FIELD CHANGE ORDER

NUMBER: DS-173Q2-F001

PROBLEM & SYMPTOM: Cross-talk problem between Dispatcher cable and switched cable. Revision incompatibility problem between M7764-00 and M7763-00 module.
(See Page 2 for more detail)

INTERCONNECTION OF MIRA MODULES (SYSTEM A only is shown)

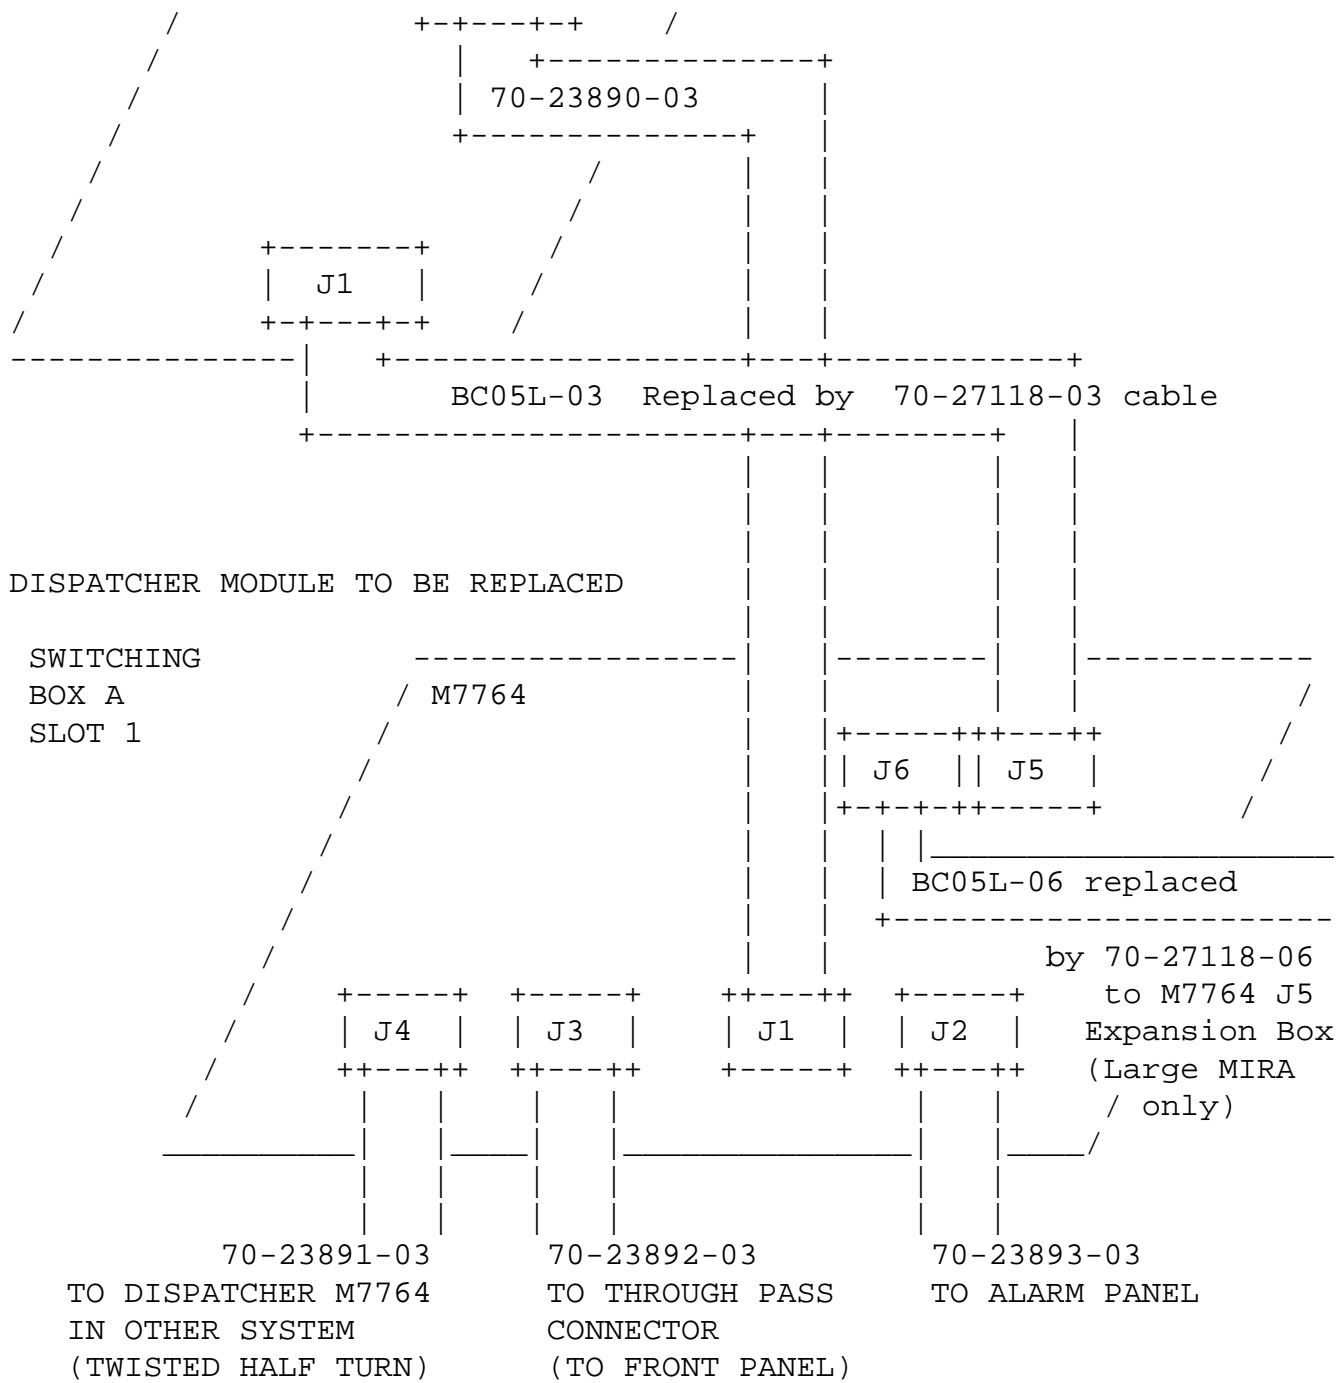
Intermittent data corruptions happen when testing switched KMV1A with XXDP Diagnostics in MIRA Systems. The data was corrupted by cross-talk between cables generated by the BC05L cable between the MIRA watch-dog Module (M7763-00) and the dispatcher Module (M7764-00).

A re-layout of the two modules M7763-00 and M7764-00 has been necessary to adapt the impedances between these modules. Both M7764 and M7763 become Revision E with the new etch. A new cable 70-27118

WATCH DOG MODULE TO BE REPLACED

Replace all modules M7763 and M7764 at Revision D or below by new modules at Rev E and replace BC05L dispatcher cables at one time.

The interconnection of the modules and cables to be replaced is shown on Page 4.
